LEGISLATIVE COUNCIL BRIEF

SHATIN TO CENTRAL LINK

AUTHORIZATION OF SCHEME FOLLOWING RECEIPT OF OBJECTIONS

Assessment of Unwithdrawn Objections and Responses of the Administration

圖則名稱 DRAWING TITLE
鐵路條例(第519章)
沙田至中環線
設定暫時佔用土地權利圖則
5頁的第1頁
 RAILWAYS ORDINANCE (CHAPTER 519)
 SHATIN TO CENTRAL LINK
 CREATION OF TEMPORARY
 OCCUPATION OF LAND PLAN SHEET 1 OF 5

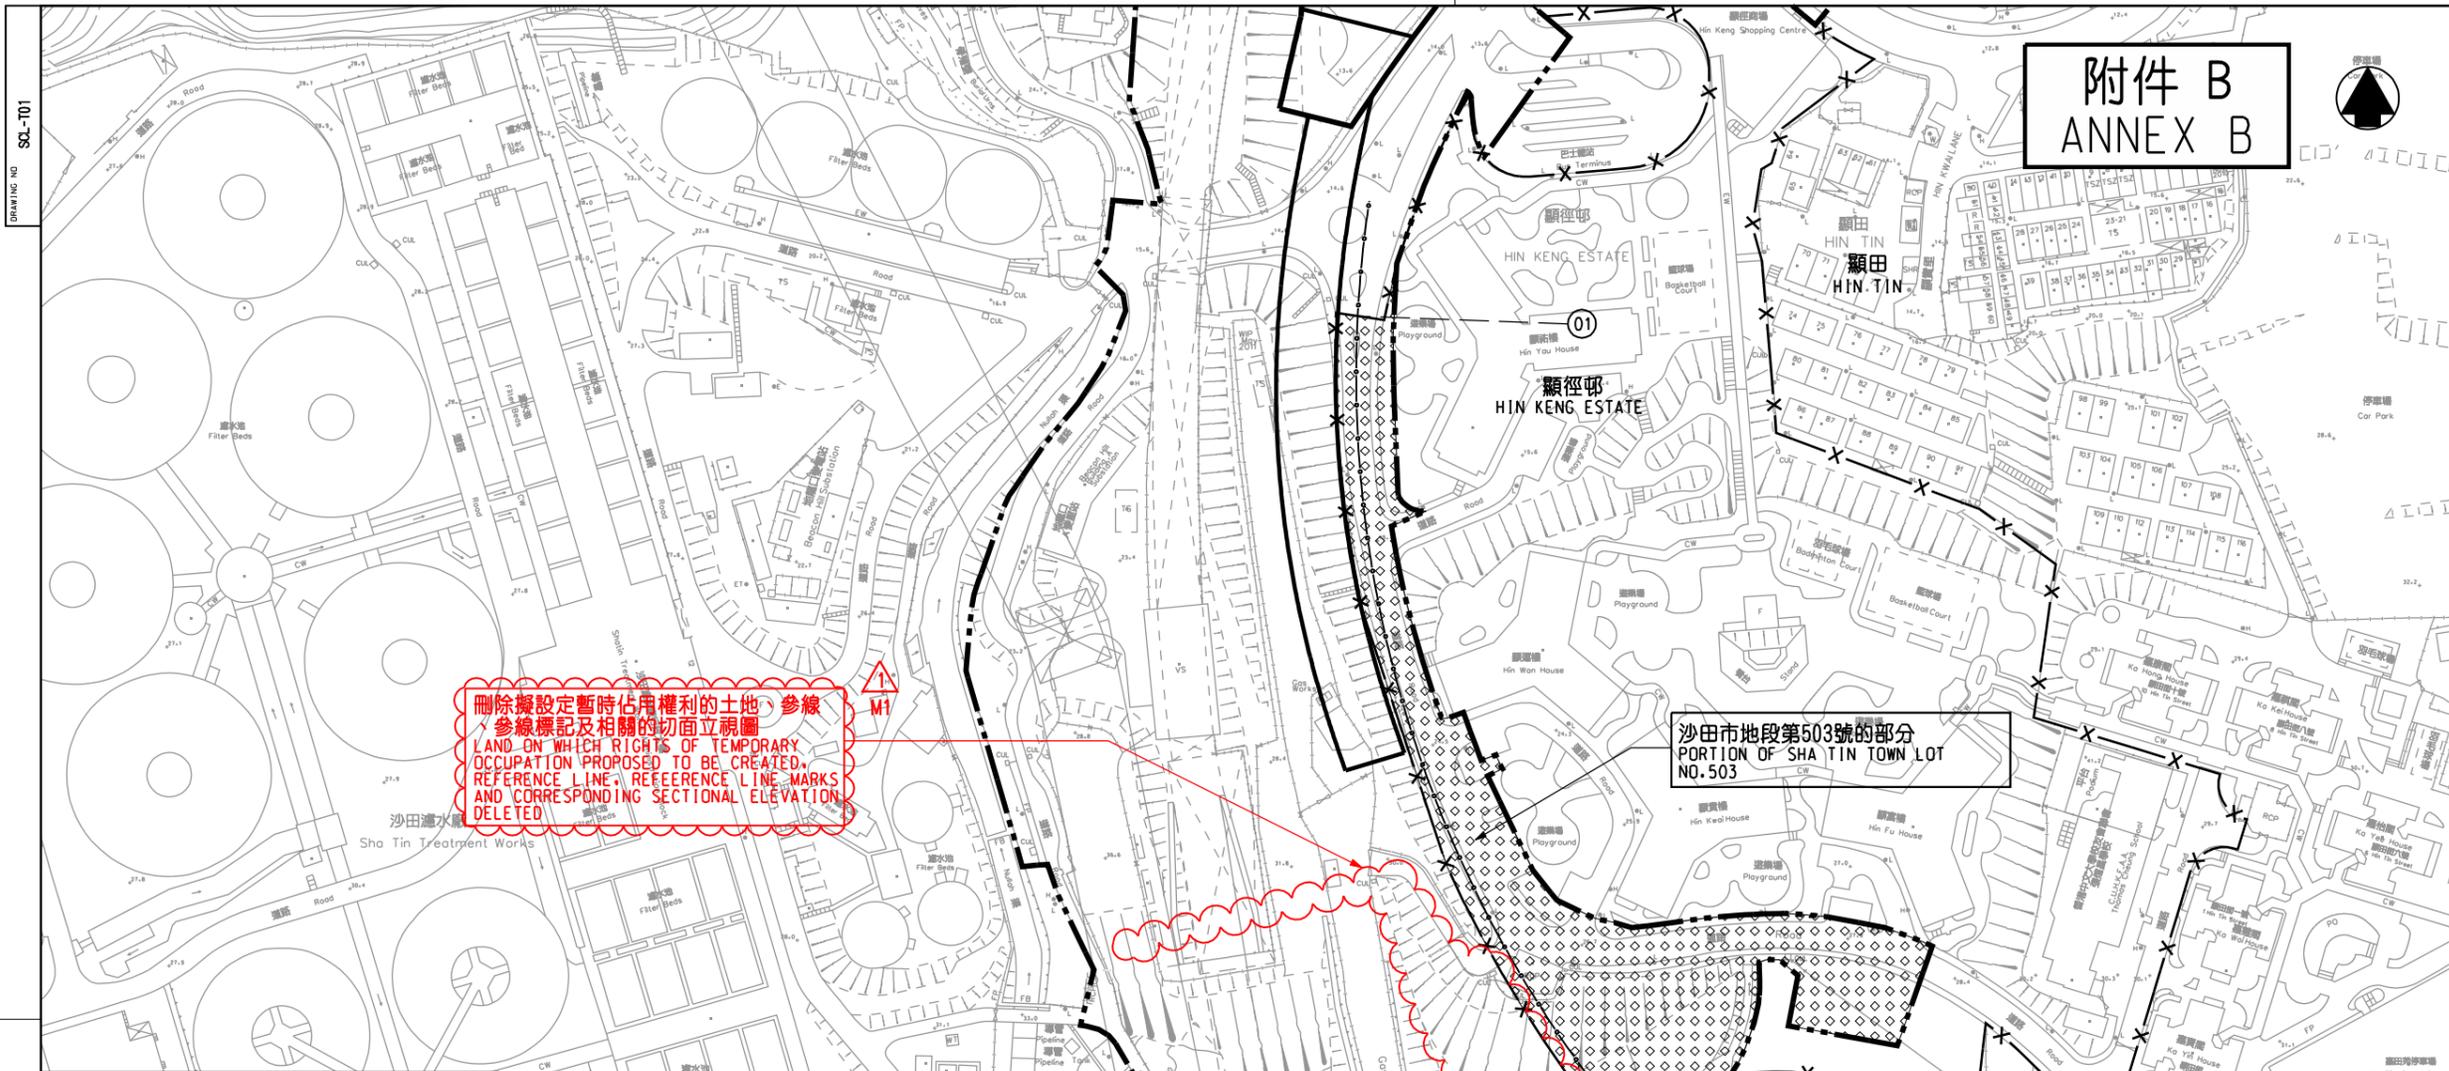
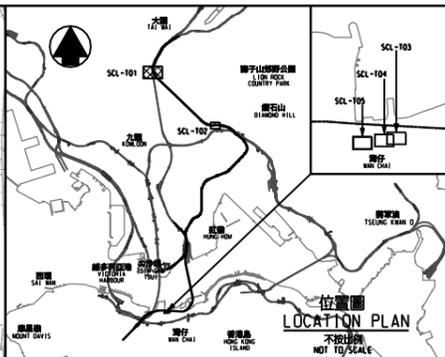
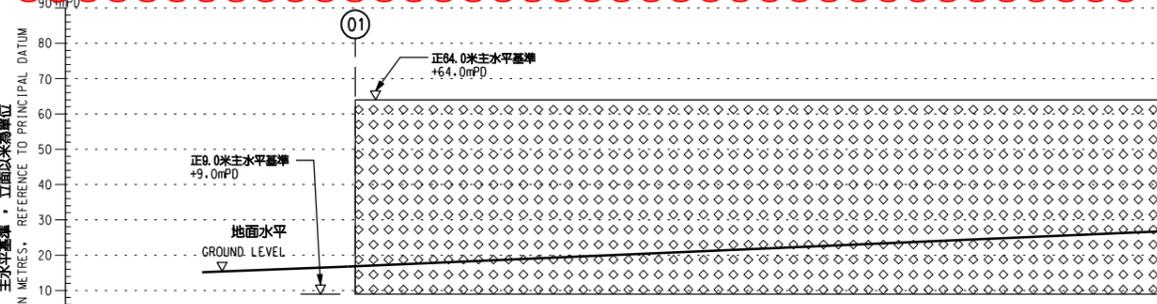
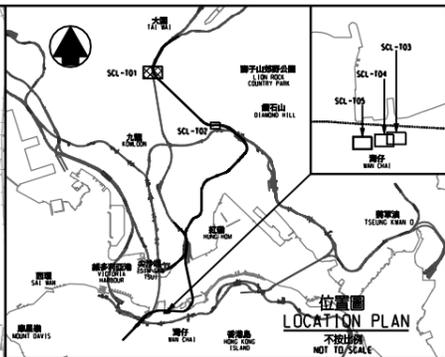
24. The Green Hatched Black Area (GHB Area) attached to Sha Tin Town Lot No. 503 (STTL 503) as shown in **Annex B** will be used as temporary working space for the construction of proposed railway facilities and underground railway tunnel. It has been proposed under the Scheme to create the rights of temporary occupation (TOA) of land for acquiring the land. However, as the Government Lease for STTL 503 stipulates that the GHB Area shall be re-delivered to the Government by the lessee upon demand from the Government, we now propose to rely on this to demand the re-delivery of the GHB Area. Hence, the creation of TOA at the GHB Area will not be required. The proposed change will not affect the boundary of the Scheme. The Secretary is satisfied that the change of TOA to re-delivery of the concerned area will have no adverse effect to the implementation of works, and therefore proposes to exclude the GHB Area of the STTL 503 (i.e. 1 932.7 square metres) from TOA as shown on the modified TOA Plan No. SCL-T01 (Revision 1) (in **Annex B**).

顯示建議修改的圖則
 PLAN WITH PROPOSED MODIFICATION
